Reference: 23082

Re: 54-58 Beaconsfield Street, Newport – Traffic Response to RFI

I have considered the relevant traffic and parking matters contained in Council's RFI (2023/1869) of 9 April 2024.

WARNING
THE LOCATIONS OF UNDERGROUND SERVICES
ARE APPROXIMATE AND BASED ON SITE.
THE EXACT LOCATIONS ARE DETERMINED ON SITE.
ALL EXISTING SERVICES SHOWN ARE NOT GUARANTEED.

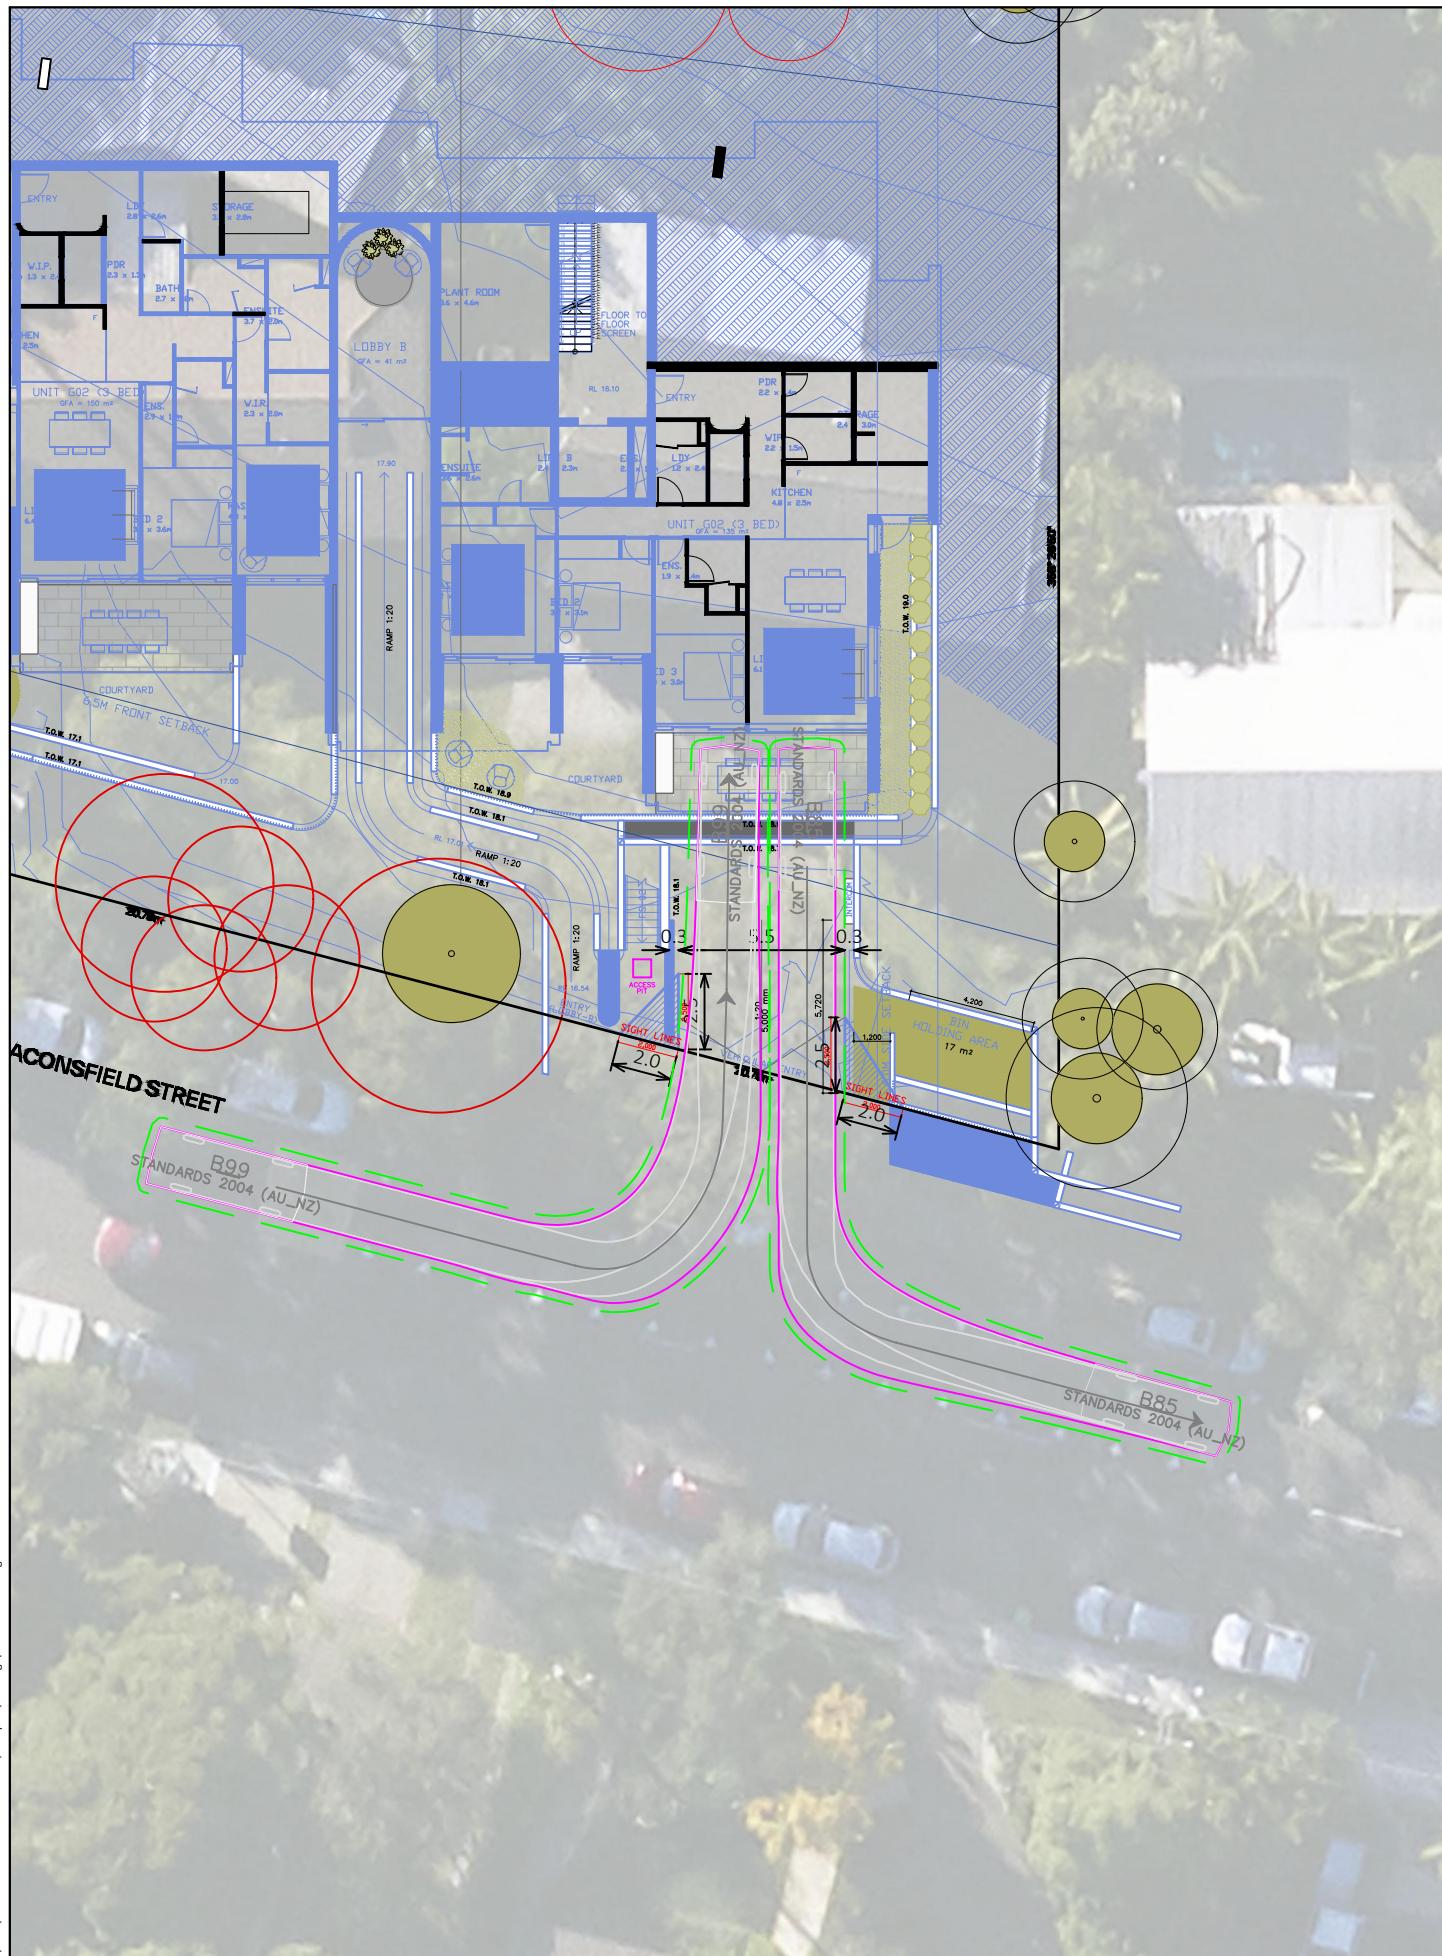
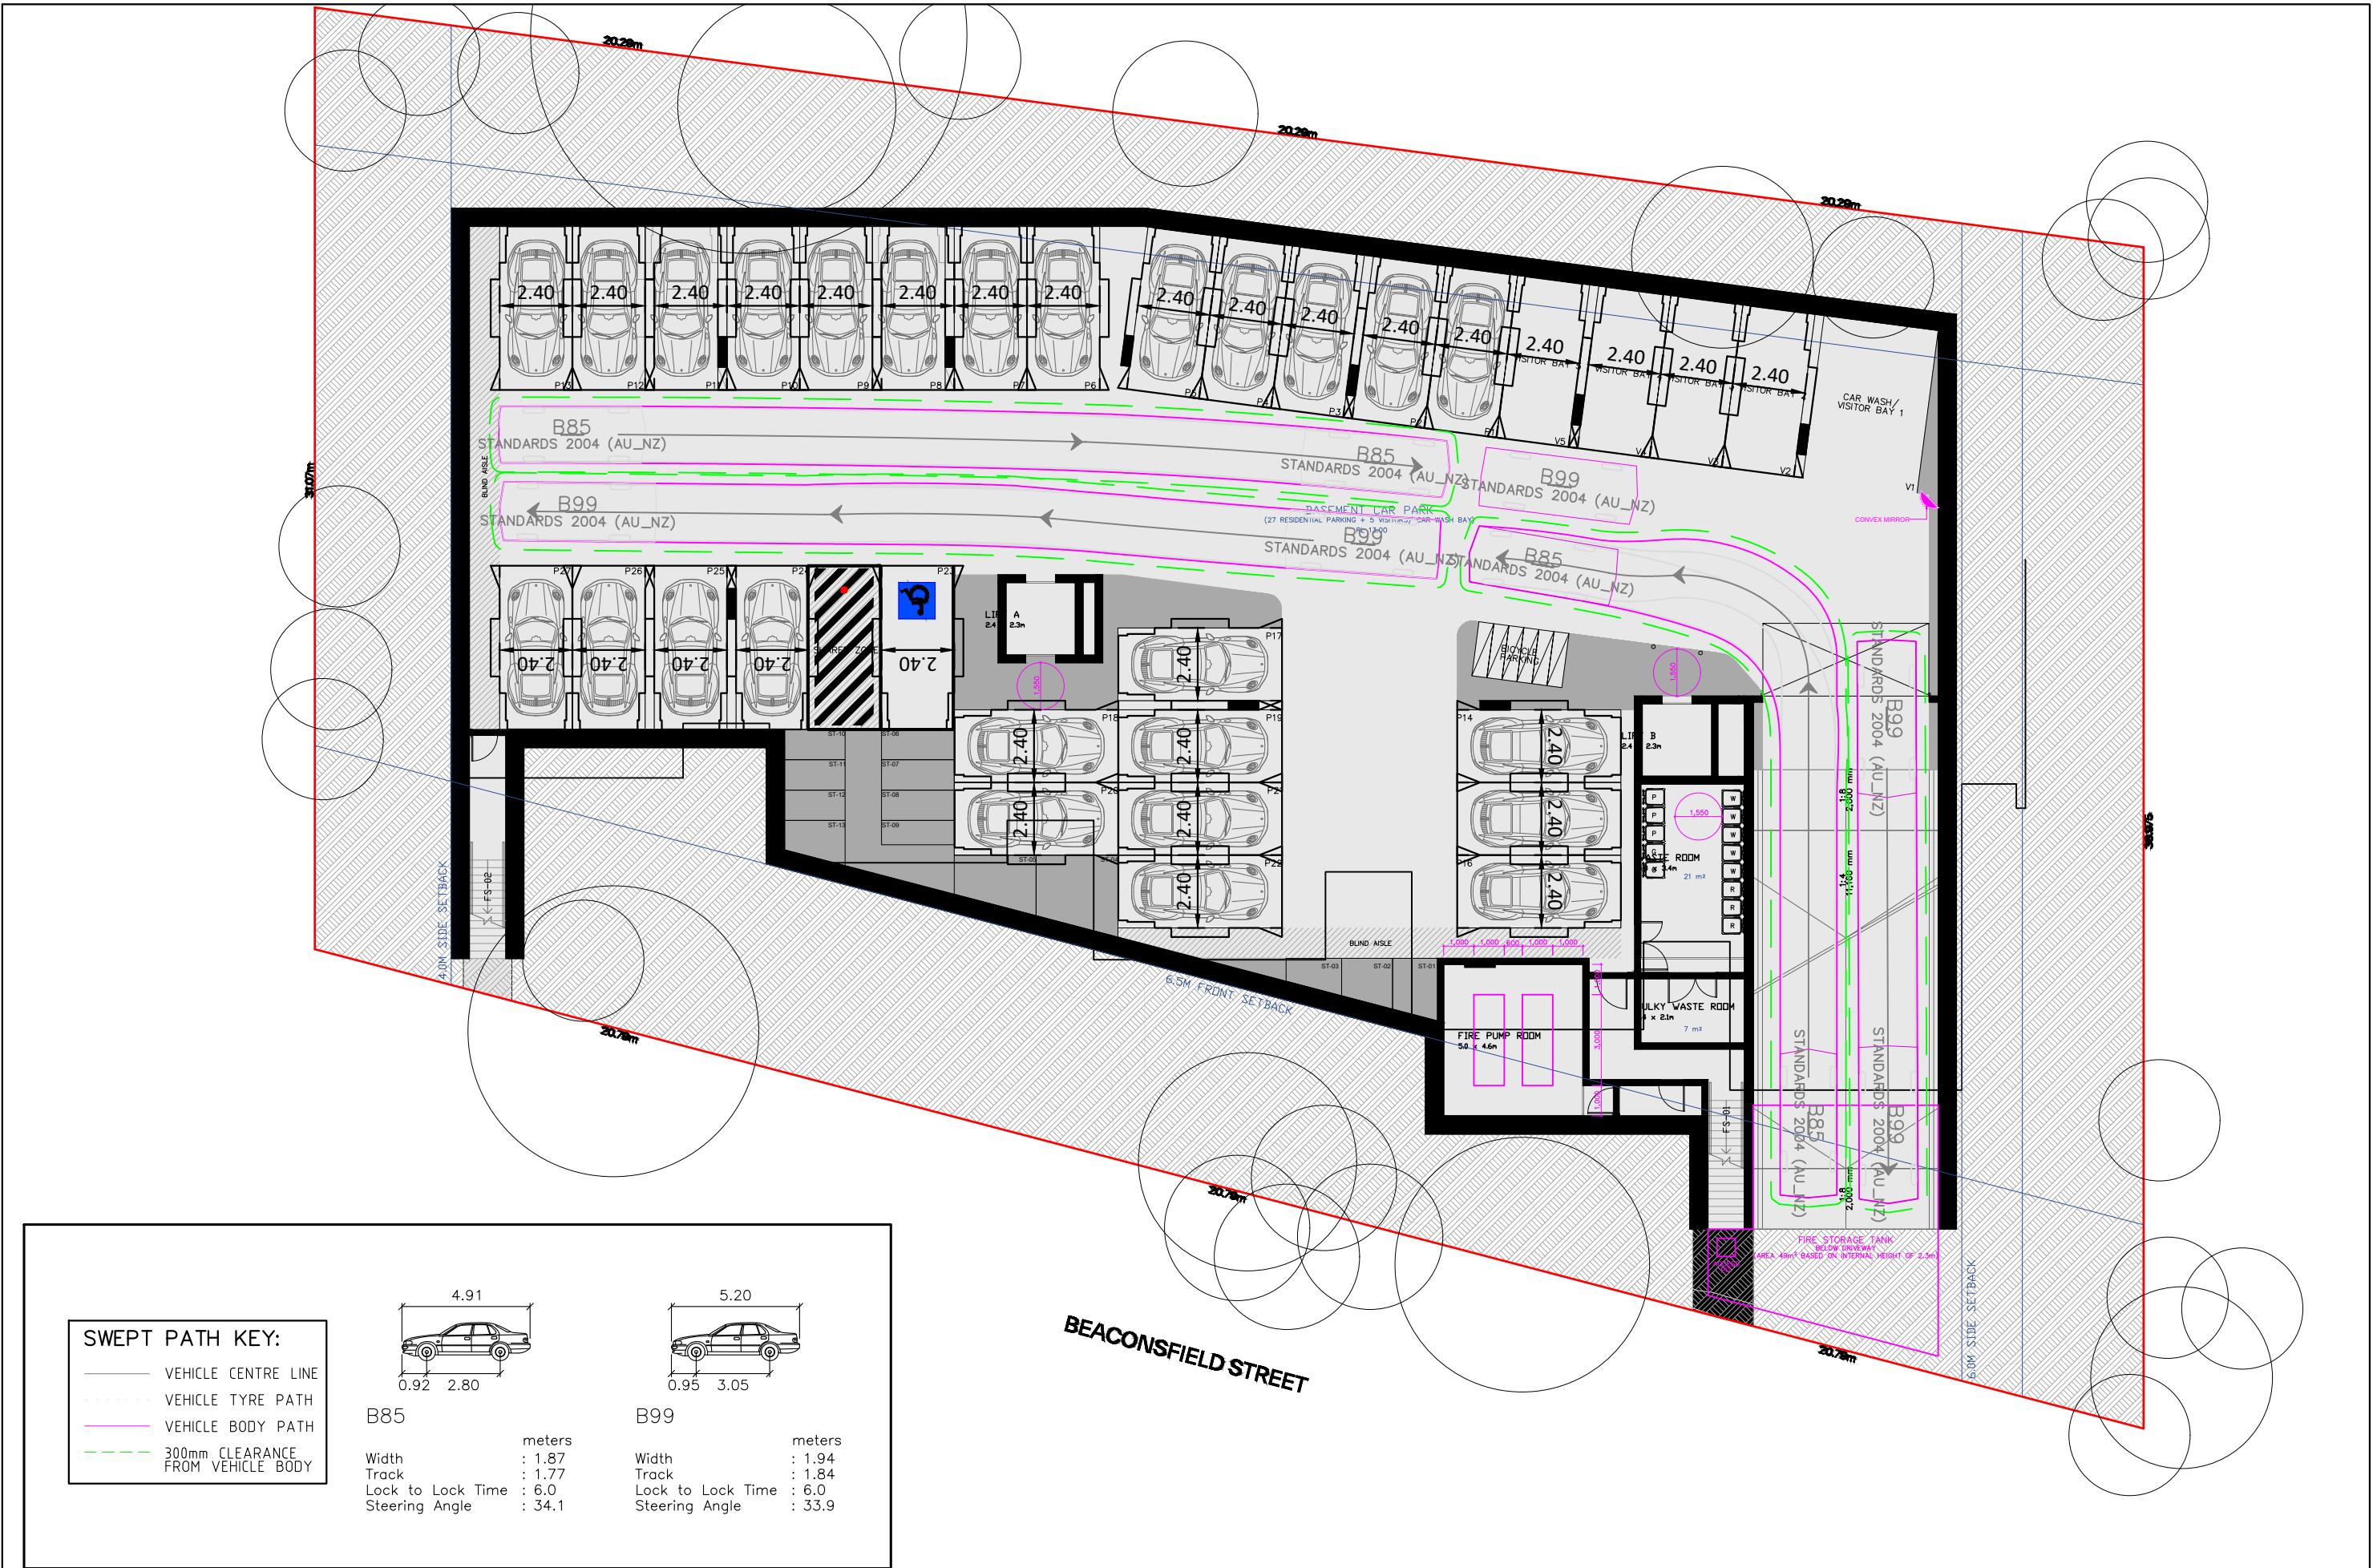
In page 28 of the Traffic Report, swept path for B85 passing B99 at the bottom of the ramp are overlapping each other. This means there is no passing achieved. Passing should either be achieved or if not possible, a stop holding line must be provided for vehicles exiting the basement, giving way to the entering vehicles. Swept paths must be amended and provided to Council's satisfaction.

In page 29 of the Traffic Report, a simultaneous passing of B85 and B99 is shown. However, the bodies of two vehicles are overlapping each other. This means there is no simultaneous passing achieved. This page should be amended for compliance with AS2890.1

The design did not intend for opposing vehicles to pass one another concurrently. For this reason, convex mirrors have been denoted on the plans, as is typical for residential car parks of this nature. The revised swept path diagrams appended to this statement indicate with clarity the available passing opportunity for vehicles in both directions.
